MANUAL IDENTIFICATION

Model Number: 8552B
 Date Printed: June 1974
 Part Number: 08552-90088

This supplement contains important information for correcting manual errors and for adapting the manual to instruments containing improvements made after the printing of the manual.

Figure 8-8. P/O 8552B Component. Assembly and Adjustment Locations (ERRATA)

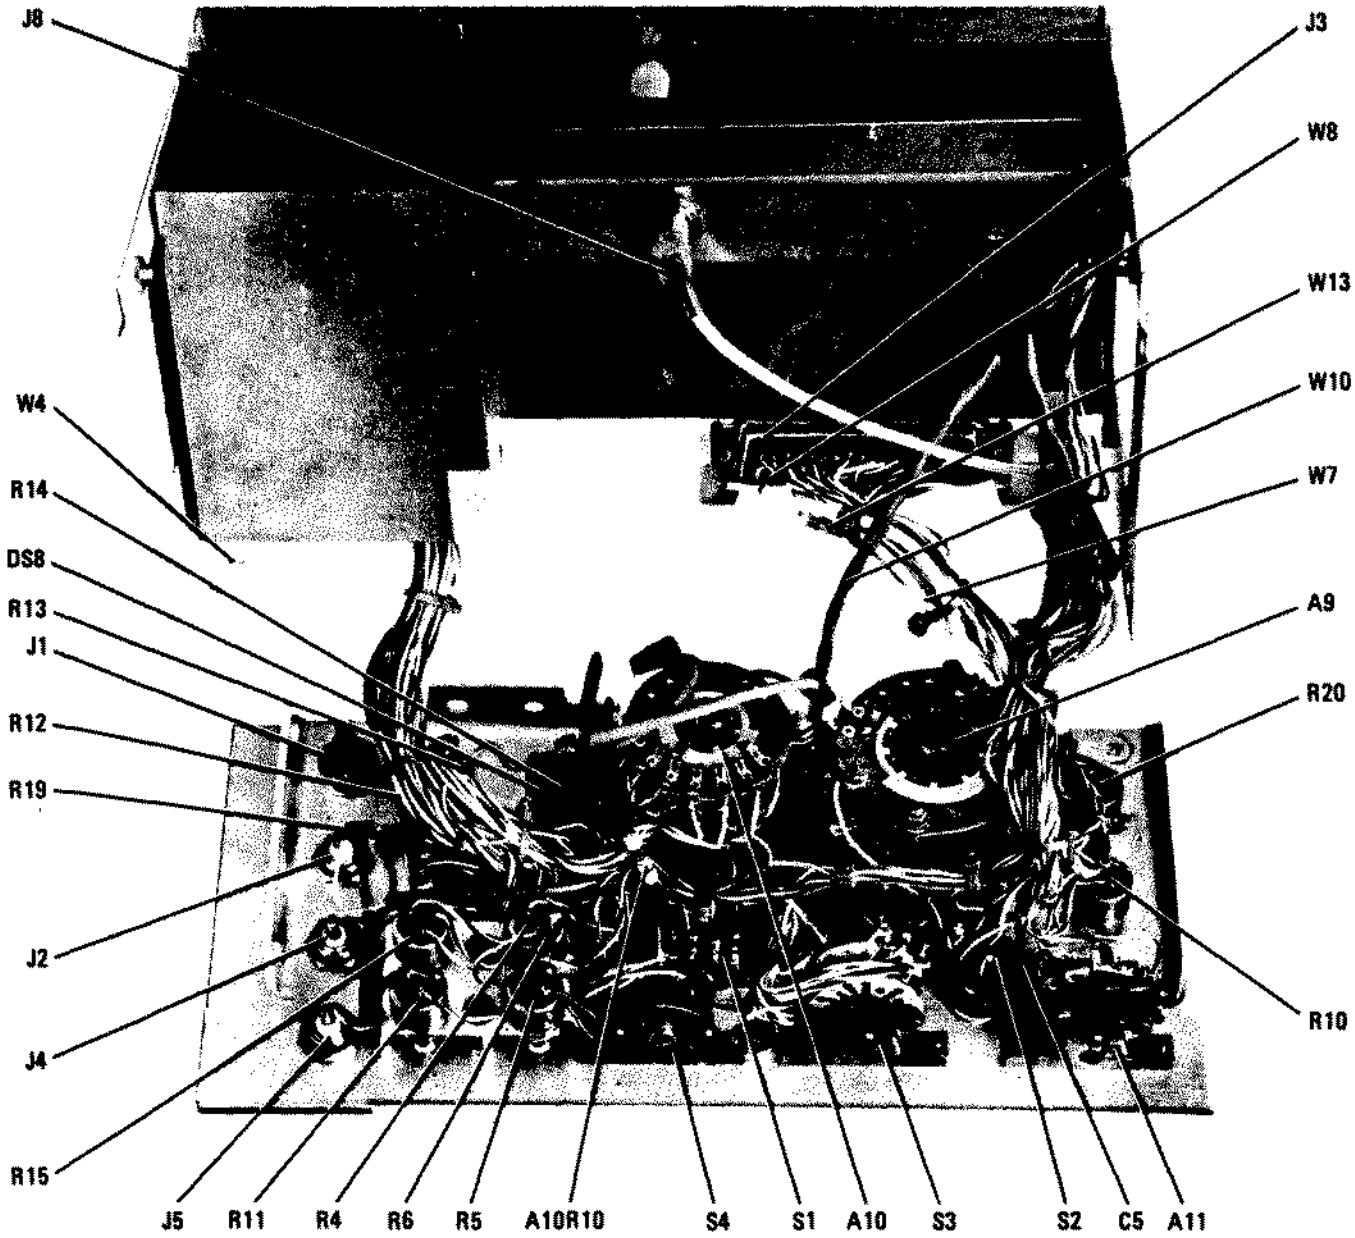
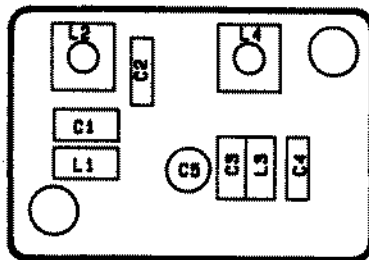
Page 8-19, Figure 8-8:

In photo entitled "INSIDE FRONT PANEL," add callout A10R10 as shown on Figure 8-8 in this Manual Changes supplement.

In photo entitled "TOP," callout W2 between XA1 and XA2 should be W12.

P/O Figure 8-24. P/O 3 MHz Amplifier A2 Component Locations

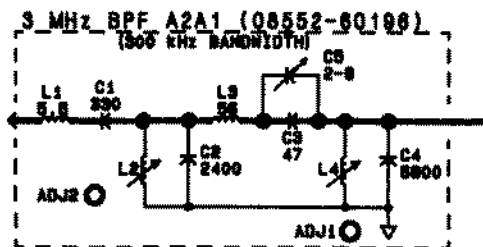
Page 8-31, Figure 8-24:

Replace small A2A1 board in upper left corner of component locations diagram with new A2A1 component locations as shown in P/O Figure 8-24 (CHANGE 19) in this Manual Changes supplement.

Figure 8-42. P/O Scan Generator A6 Component Identification (CHANGE 13)

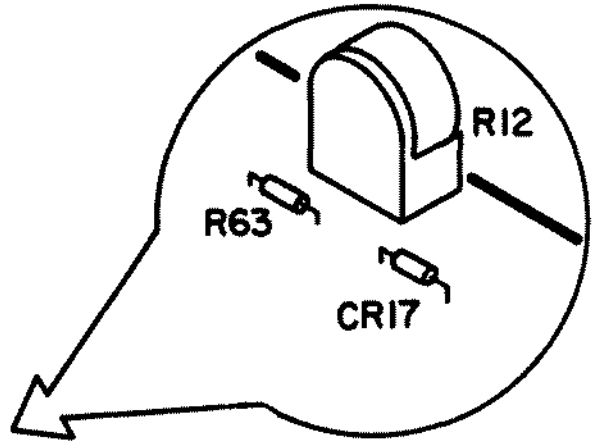
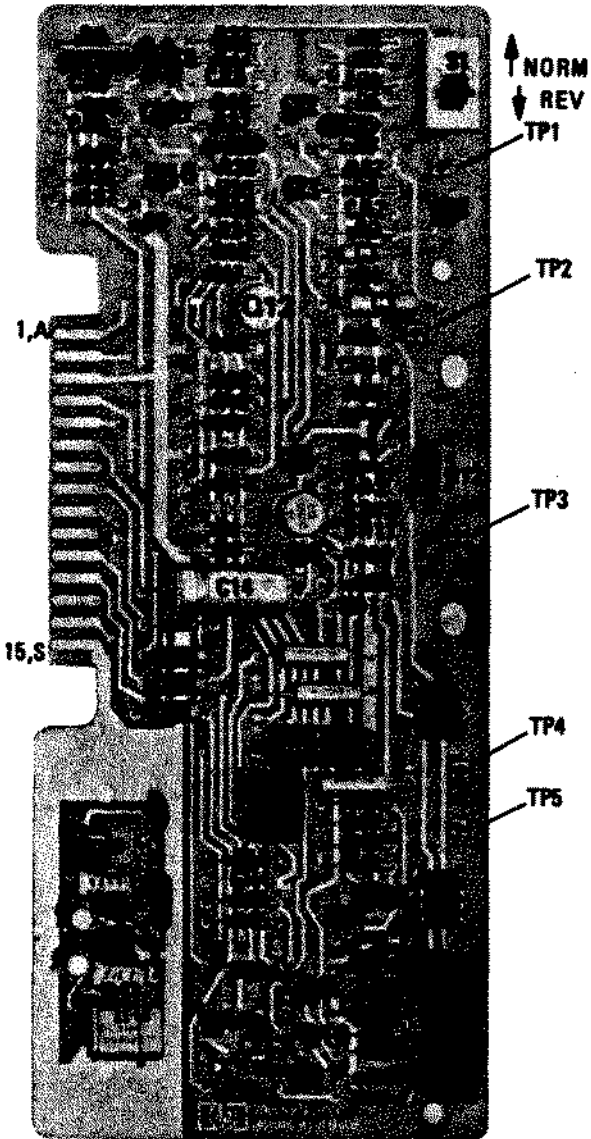
Page 8-49, Figure 8-42, SERVICE SHEET 15:

Add new components as shown in Figure 8-42 of this change sheet.

Figure R-13 Scan Generator and Trigger Circuits (CHANGE 13)

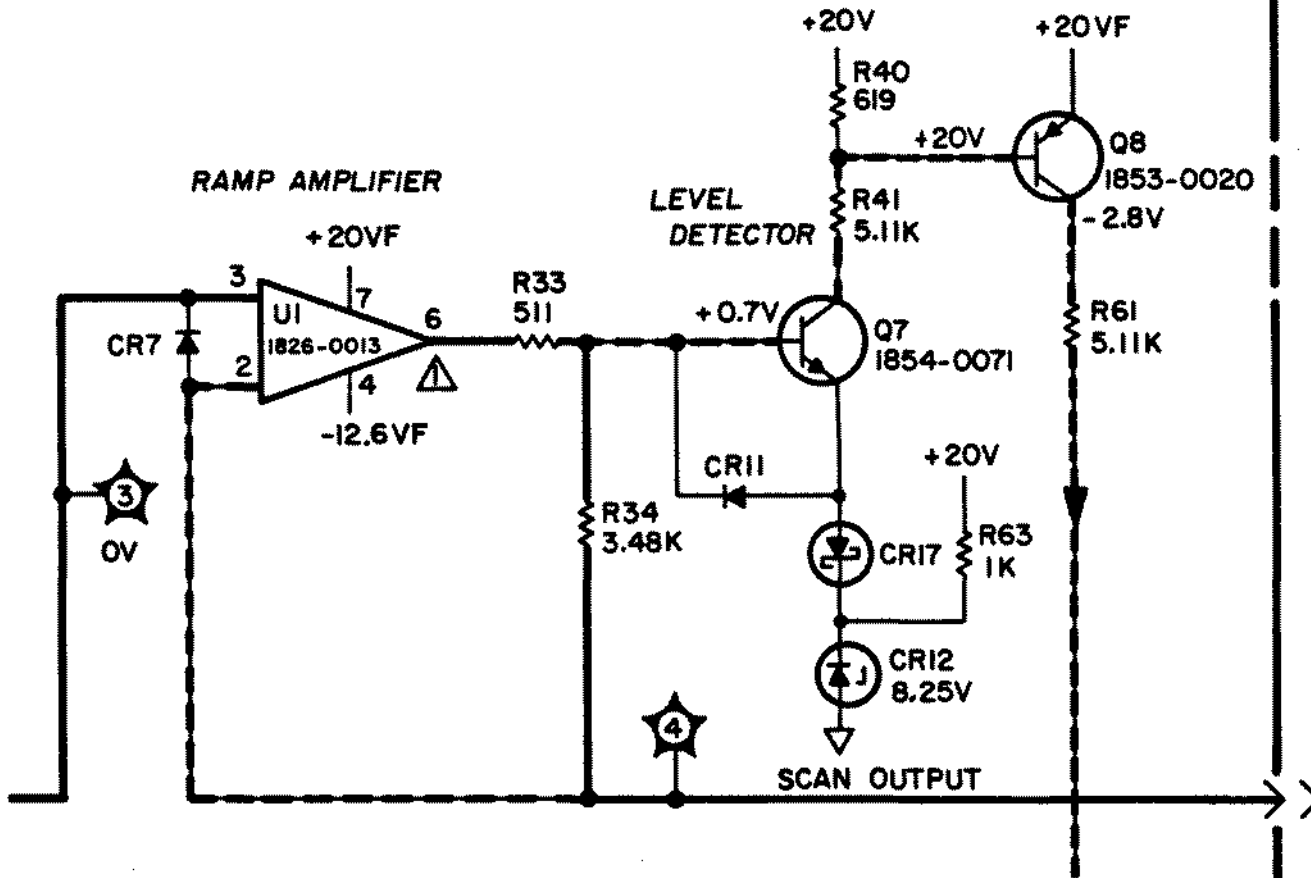
Page 8-49, Figure 8-43, SERVICE SHEET 15:

Add A6CR17 and A6R63 as shown in Figure 8-43 of this change sheet. Change breakdown voltage of A6CR12 from 9V to 8.25V.

Add CR17 and R63 to REFERENCE DESIGNATIONS table under A6.

FIGURE 8-24 AND 8-26. P/O 3 MHz AMPLIFIER A2 COMPONENT IDENTIFICATION (CHANGE 20)

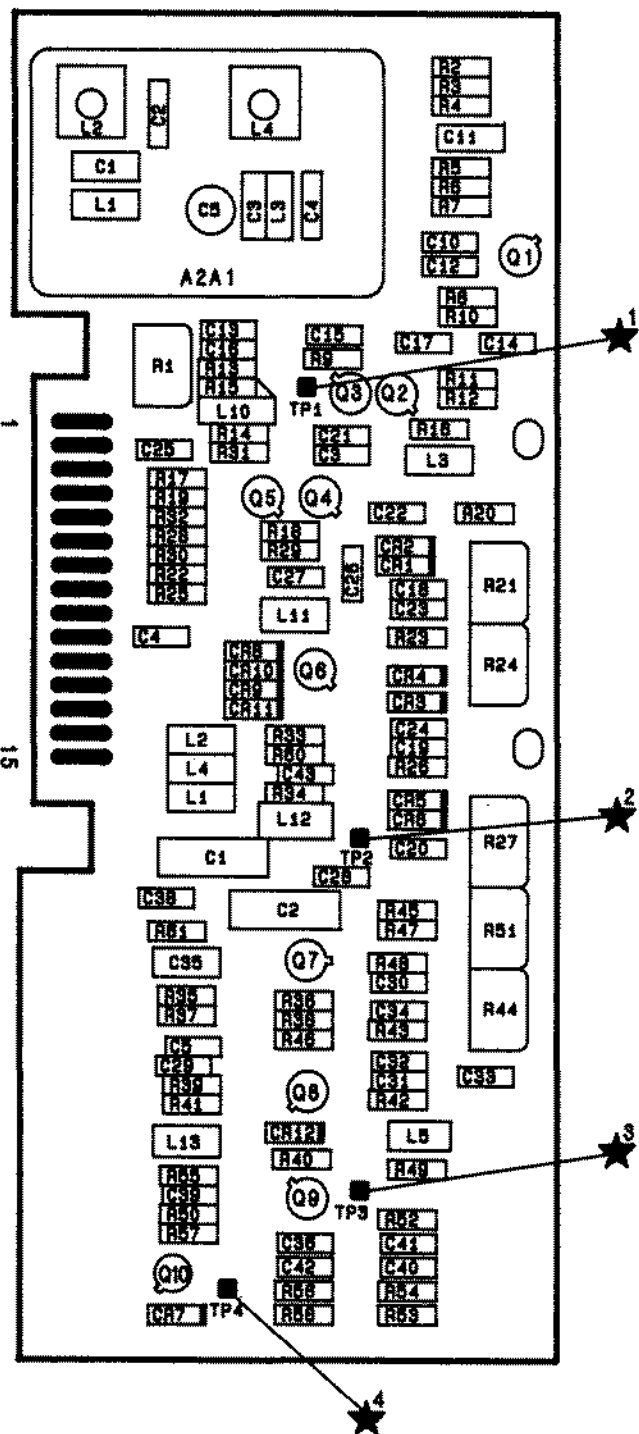
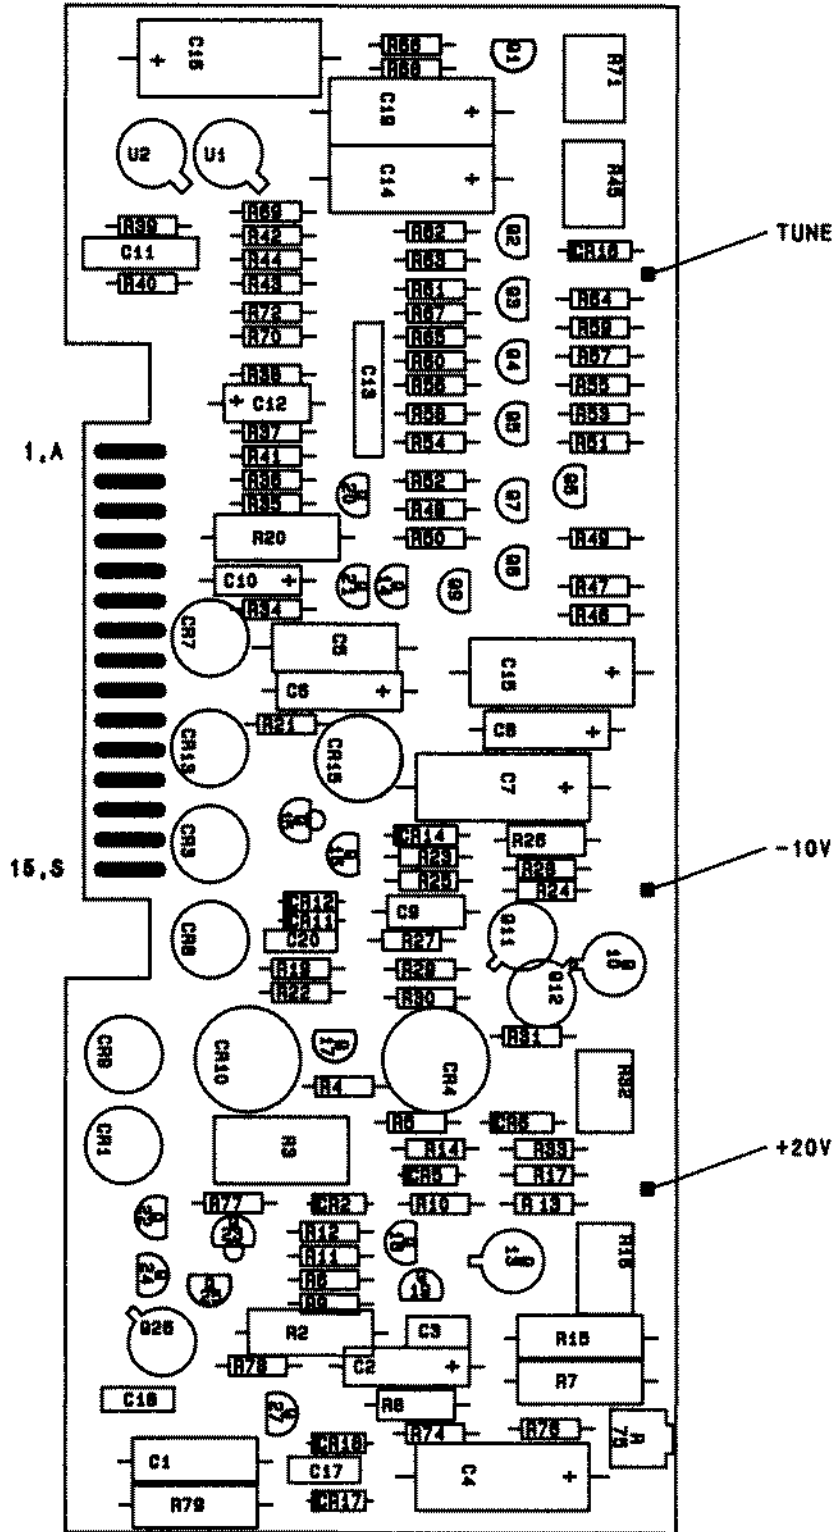
Page 8-31, Figure 8-24:

Page 8-33, Figure 8-26:

Replace the figure with the new Figure 8-24/8-26 (CHANGE 20) located in this Manual Changes Supplement.
